LiDAR Quality Assessment Report

IN_Statewide-Opt-B1_2017

NGTOC
 2018-03-14
 Sarah klaas

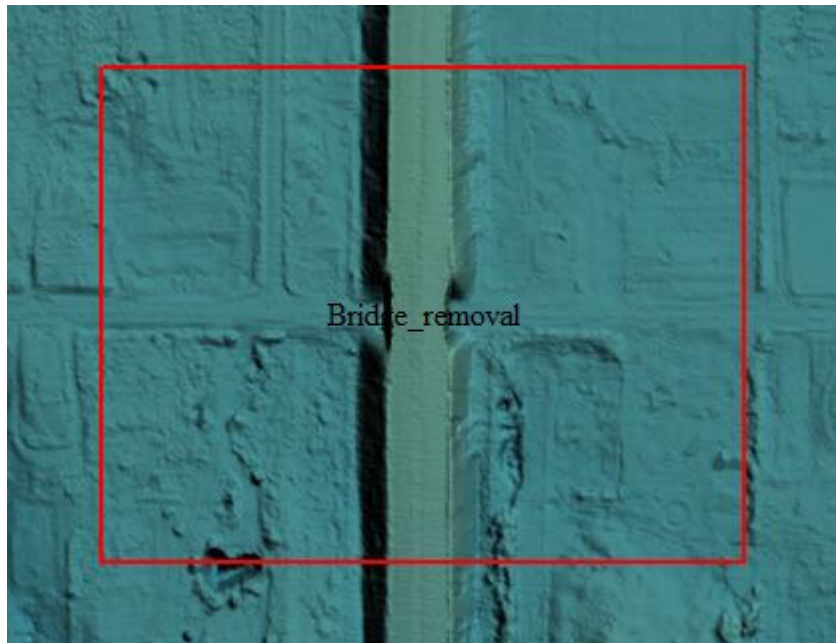
Two waterbodies larger than 2 acres were not hydroflattened (3/14/2018) Corrected 4/4/2018

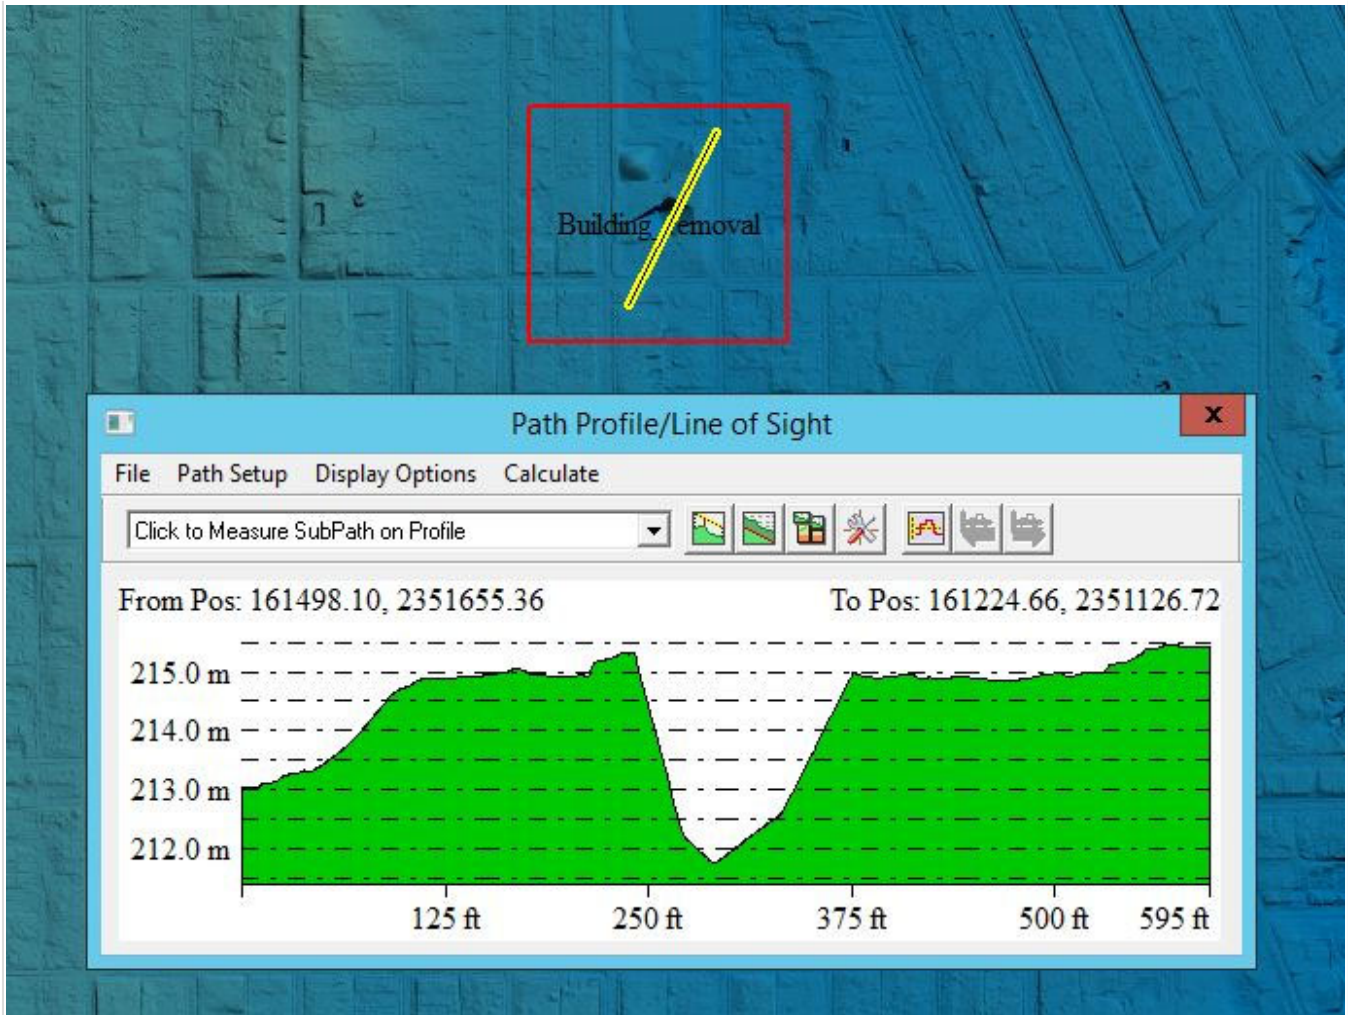
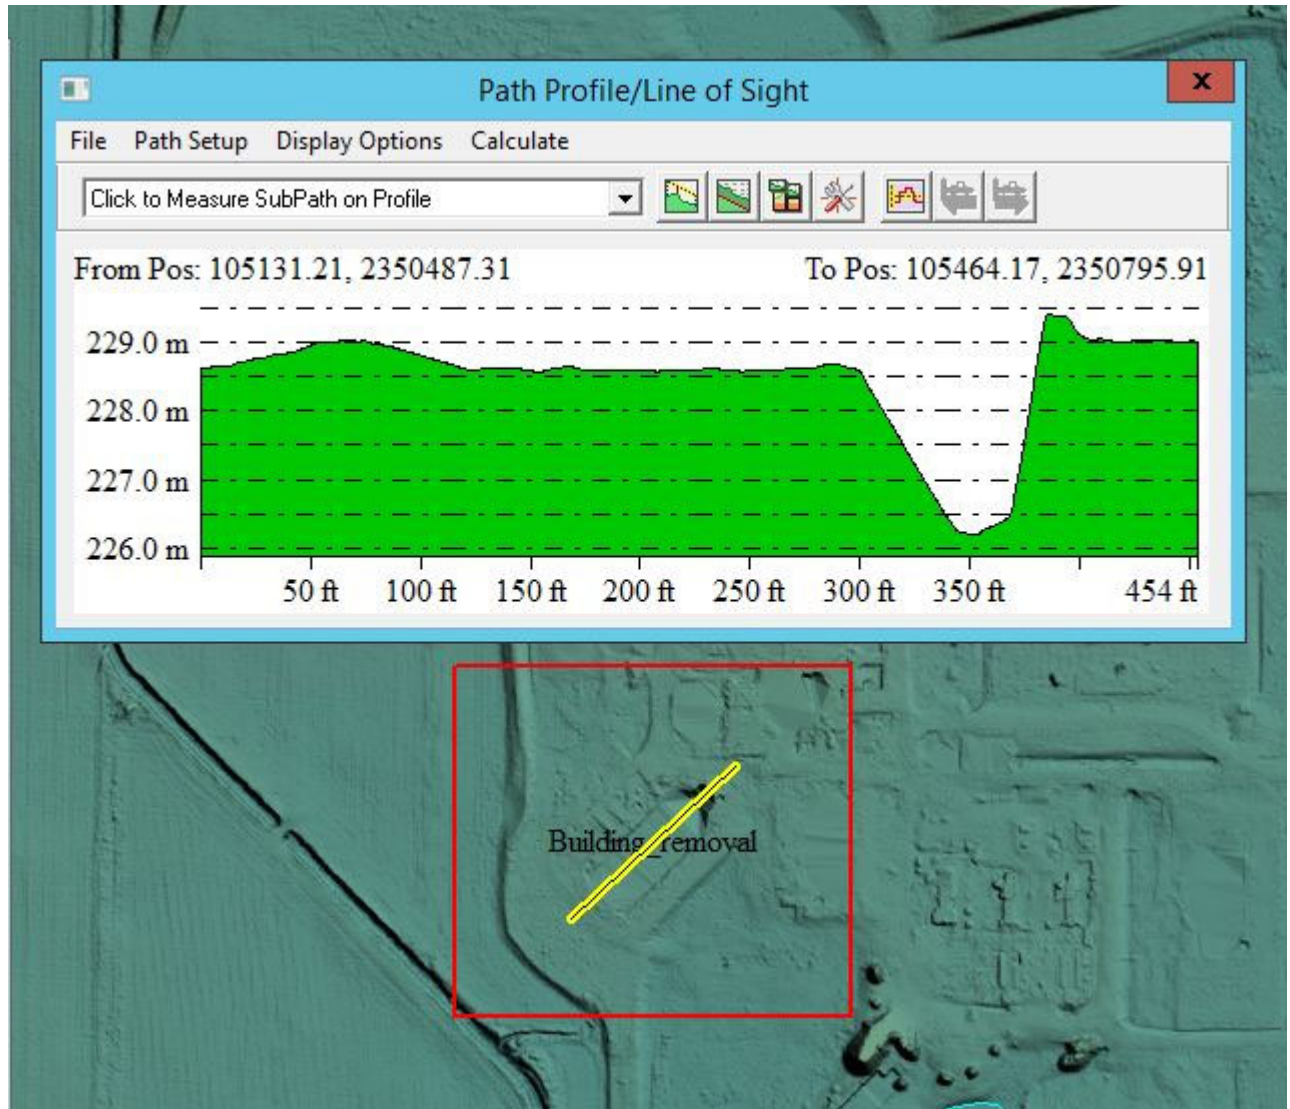
4 Bridges were not removed, two examples of this error can be seen below. (3/14/2018)

Corrected 4/4/2018
